Project title	Bega Valley Health Service Hospital Development - Review of Flooding Aspects	Job number	224753-00
cc	Michael Brooks Nic Johnstone	File reference	
Prepared by	Andrew Moore Claire Moore	Date	9 August 2012
Subject	Bega Valley Health Service Hospital Development - Review of Flooding Aspects

Arup has been engaged to undertake a review of an assessment of flooding aspects prepared by WMAwater ('Bega Valley Health Service Hospital Development Flooding Aspects', WMAwater, 27th March 2012) [Reference 1]. This review has included a review of the available data, a re-assessment of the estimated flood levels at the site and provides further commentary on relevant land use planning policy and flood risk management guidance documents.

Figure 4 Cross-sections through site

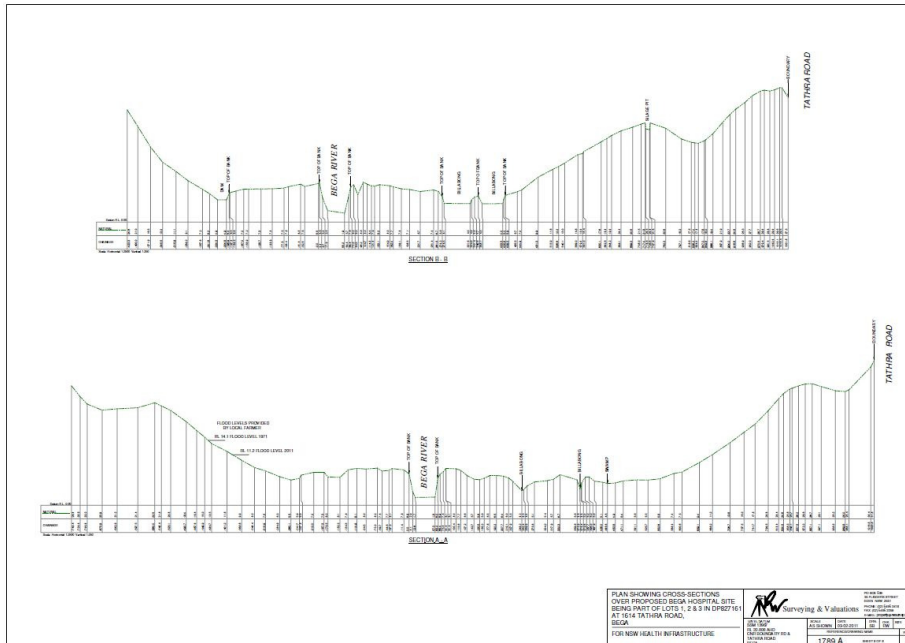
The channel cross-section information in Figure 3 and Figure 4 (Section B-B) has been used to derive cross-sectional area and wetted perimeter information for varying elevations. These have then been input to the Mannings equation to calculate the resultant peak flow at each elevation. The results from this assessment are sensitive to the roughness (Mannings 'n') value assumed within the calculation.

The results in Table 3 reflect this range in roughness values. An elevation of 15 mAHD constitutes a rise of only 1m above the 100 year ARI event peak level and this is considered to be an unrealistically small increase in peak level between these two events. It would be reasonable to expect a rise of at least 2m between the 100 year ARI event and the PMF, although it should be highlighted that this rise can be considerably greater.

Based on the initial PMF peak flow estimate and guidance on appropriate range of roughness values, the PMF peak level at the site can be expected to lie between 16.0 and 18.25 mAHD. This range takes no account of any back-water effects arising from the impact of structures or constrictions in the channel, nor from any effects of elevated sea levels at the mouth of the Bega River Estuary.

Due to the high-level nature of this PMF analysis, coupled with the assumptions documented above, a conservative approach is highly recommended. Therefore, a PMF peak level of 18.25 mAHD should be utilised within any subsequent land-use planning and/or early design phases. This compares with a level of 20.5 mAHD within the WMAwater study [Reference 1]. It is also stressed that further, more detailed assessment of the actual PMF flow and level should be undertaken to confirm this level.
